SERVICE BULLETIN

B-080A

Safety Recall Code 0835

2007, 2008 and 2009 MODEL YEAR BUELL BLAST FUEL TANK RECALL

Figure 1. Existing Bracket

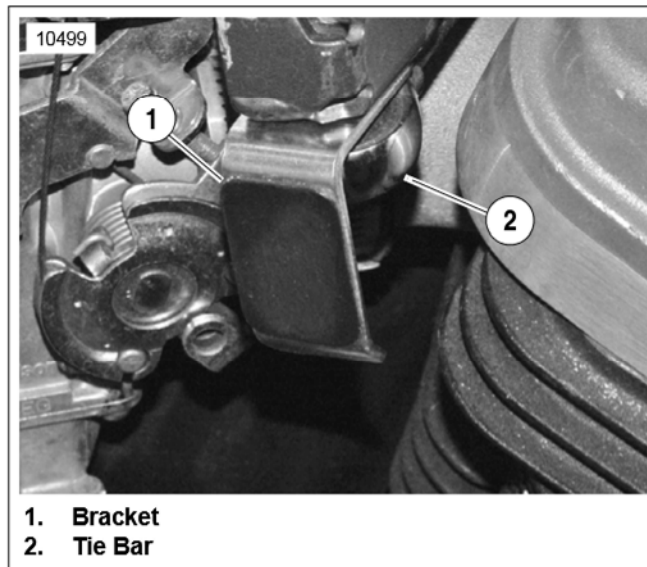
3. See Figure 1. Remove existing bracket (1) from tie bar (2). Discard old nut and retain screw for assembly.

Figure 2. Install and Align New Bracket

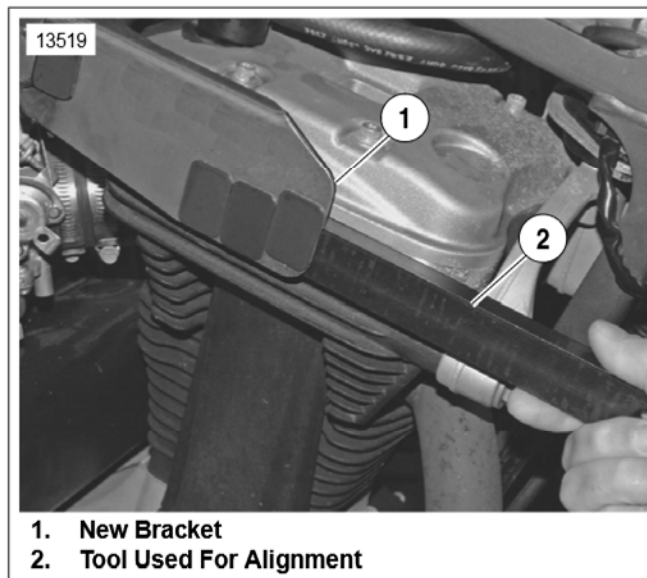
4. See Figure 2. Using screw retained during removal process, **new** locknut, and Shift Lever Substitute Tool (HD-45338) (2) to provide 0.5 in. (12.7mm) clearance between fuel tank and cylinder head, install **new** bracket (1) provided in kit.

Figure 3. Bracket Properly Seated

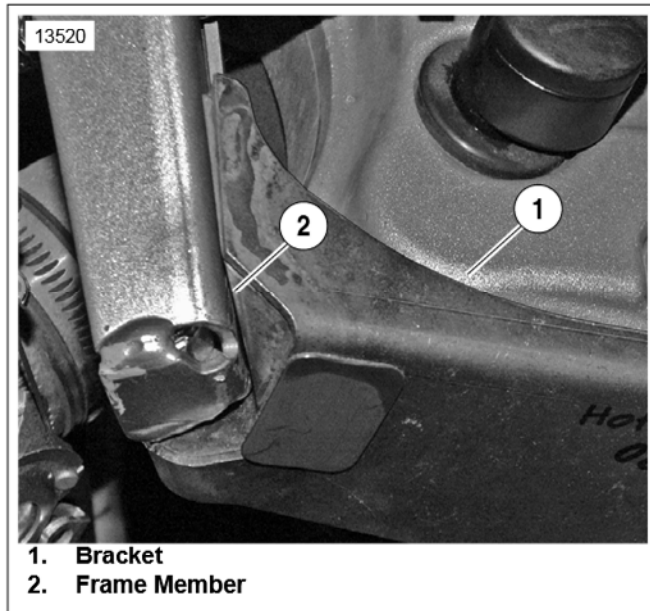
5. See Figure 3. Verify back of bracket (1) is properly seated against frame member (2) as shown.
6. Hold Shift Lever Substitute Tool in place and tighten bracket screw to 30-33 ft-lbs (41-45 Nm). Remove tool after tightening screw.

Figure 4. Fuel Tank Insulation

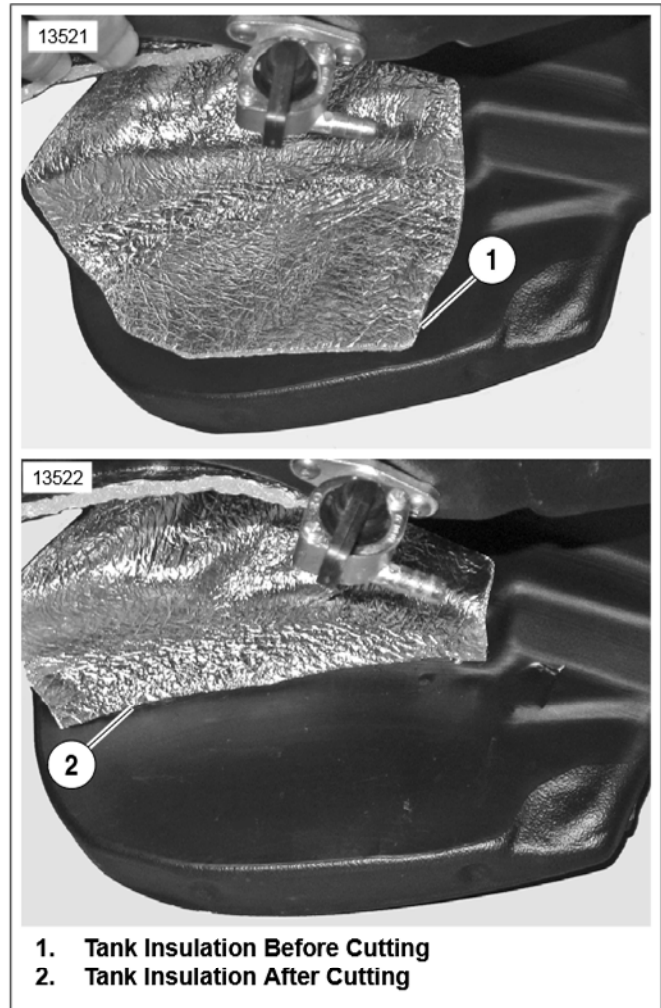
7. See Figure 4. Trim existing tank insulation to provide proper clearance to **new** bracket.
8. Install fuel tank and fuel tank cover per procedure in appropriate year and model service manual, using **new** wire tie and clamp provided in kit.
9. Install main fuse.
